SUNTOP SOLAR FARM

MODIFICATION APPLICATION 1
DEVELOPMENT CONSENT SSD 8696

JULY 2019

The application to modify the development consent involves relocation of the substation and ancillary infrastructure, increased landscaping, a minor administrative change to the Site Plan and modifications to the originally submitted subdivision layout corresponding with the substation relocation.

FIGURE 2: PROPOSED MODIFIED SUBSTATION LOCATION (provided by EnergyForms, 19 July 2019)

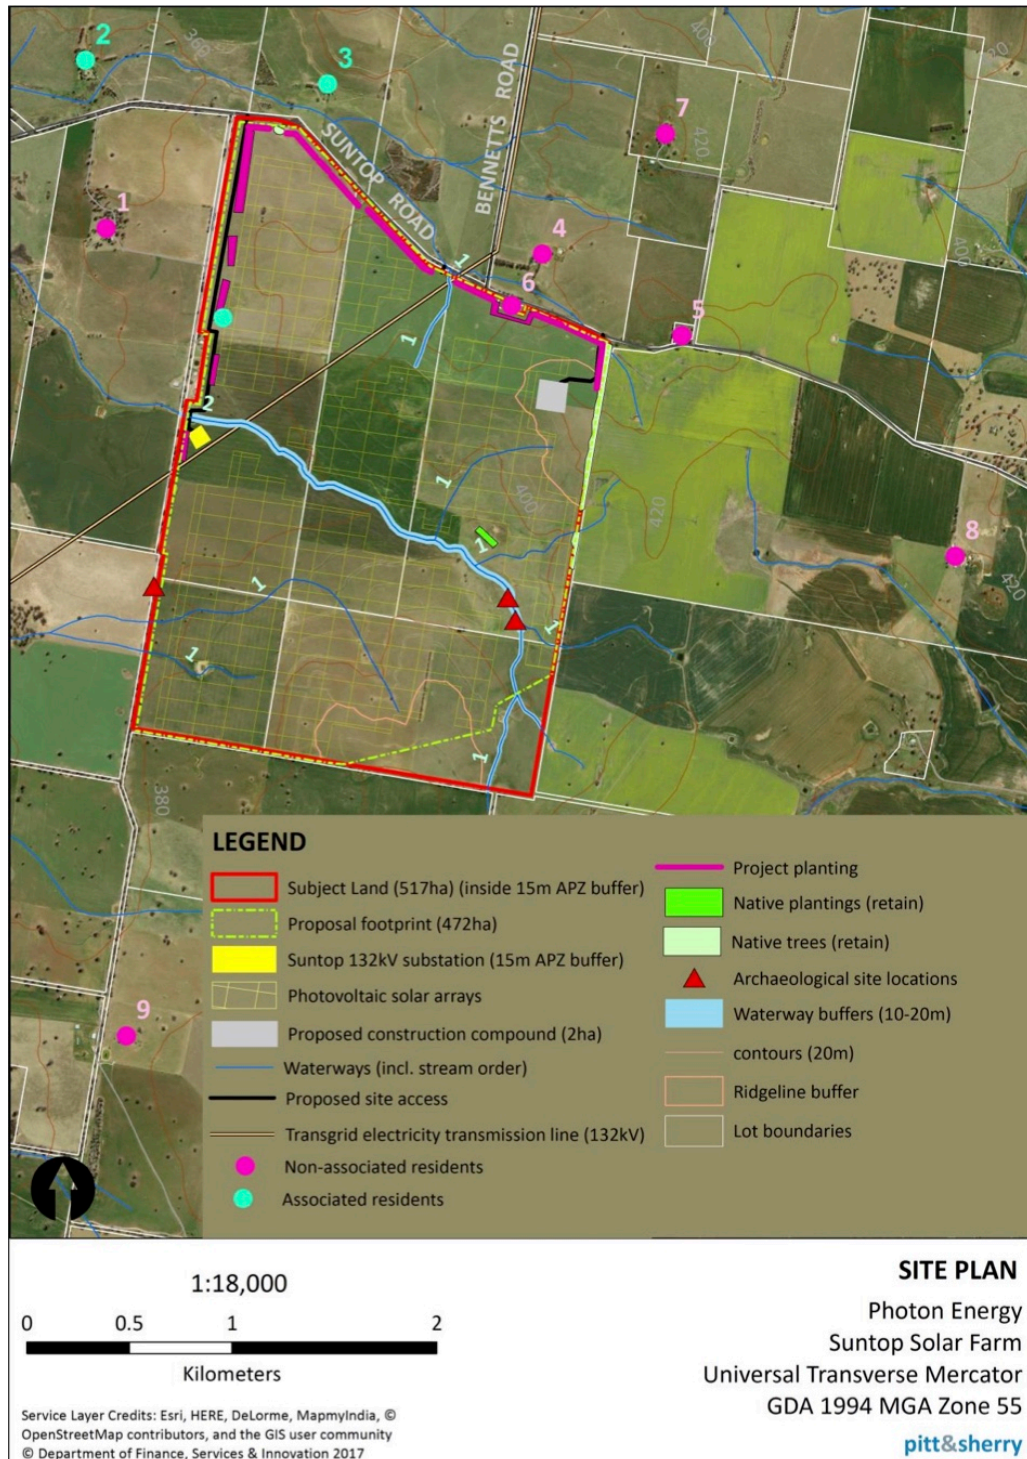
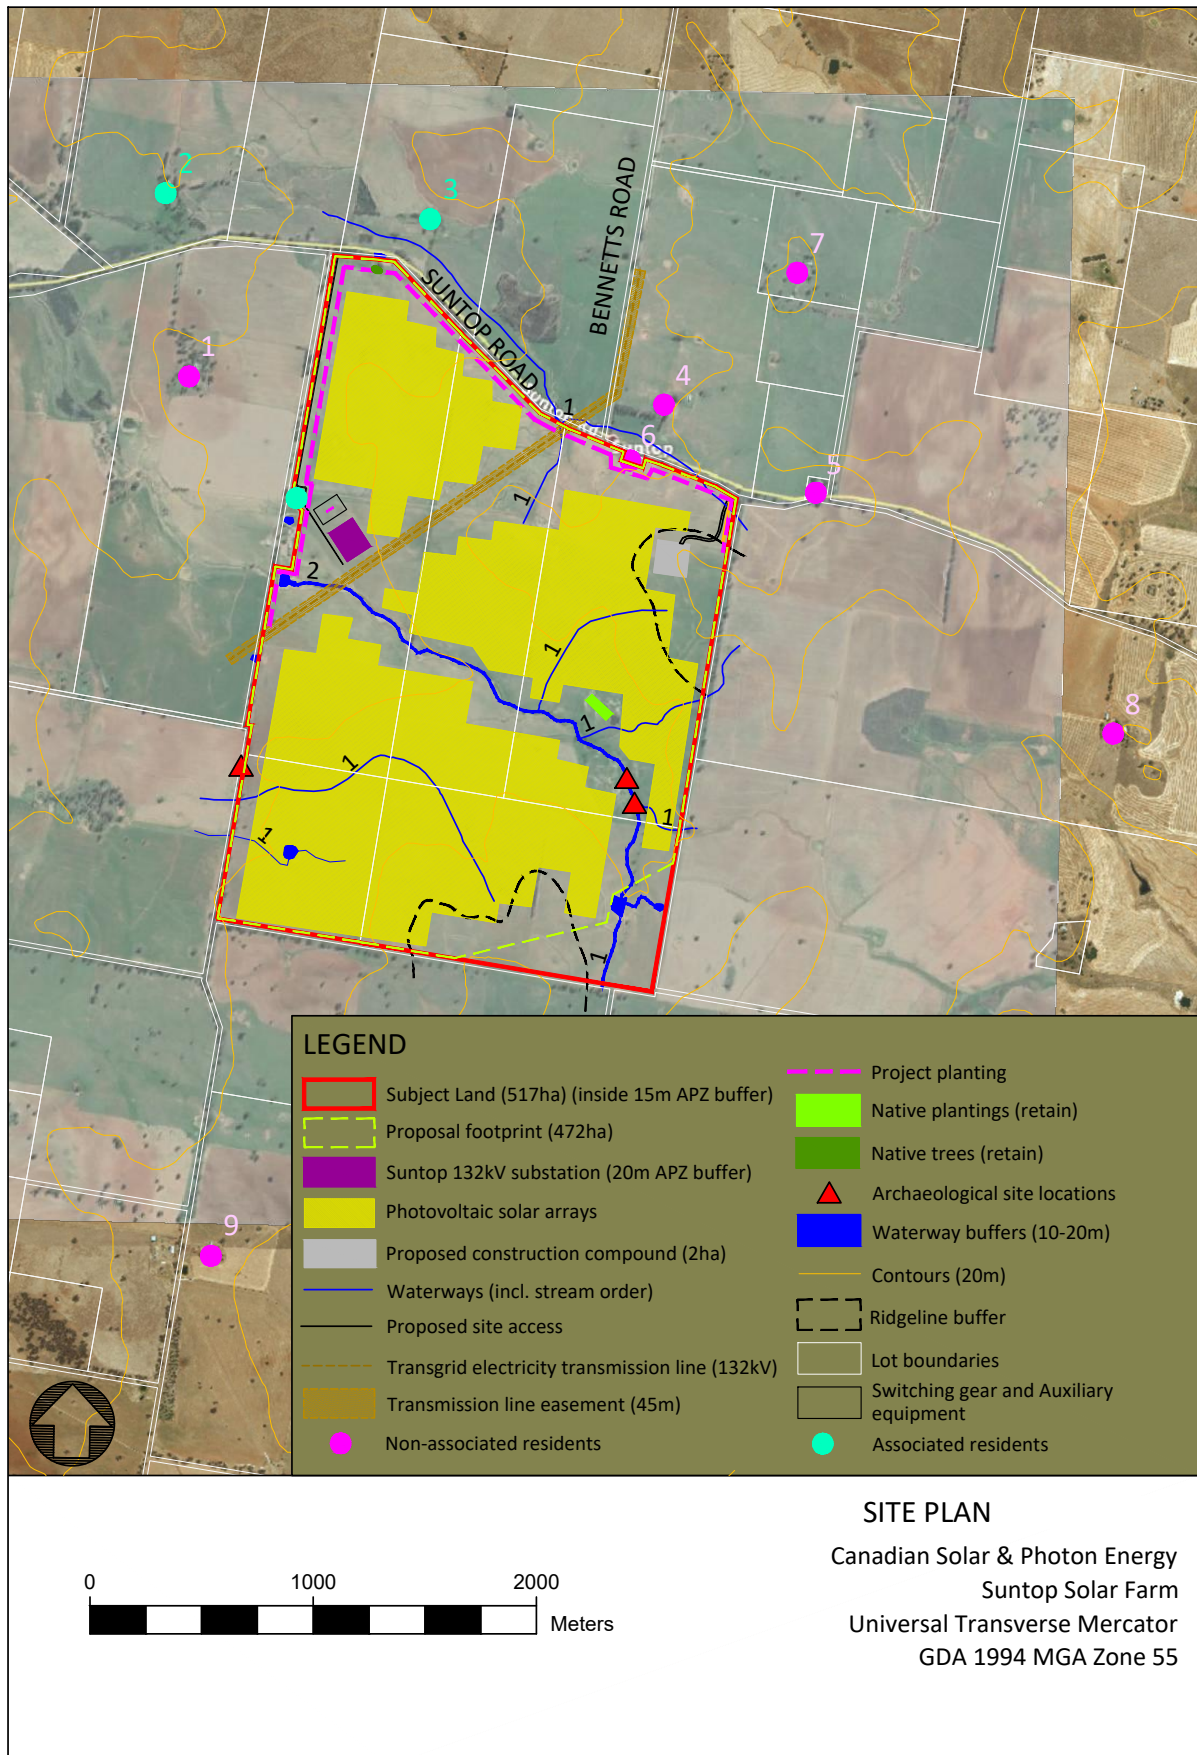
The approved position of the substation is shown **FIGURE 1** (Appendix 1 of the Development Consent).

- the relocation of the substation to the north west side of the Transgrid transmission line and north of the waterway. The proposed modified position of the substation is shown **FIGURE 2**.

- Separation of the substation into two key components being:
 - The main substation containing the transformer(s) and connection into the grid (shown in red on **FIGURE 2**)

- The E-house containing up to 4 X 40ft containers to house medium voltage (MV) and low voltage (LV) switchgear as well as auxiliary equipment (shown in blue on **FIGURE 2**).
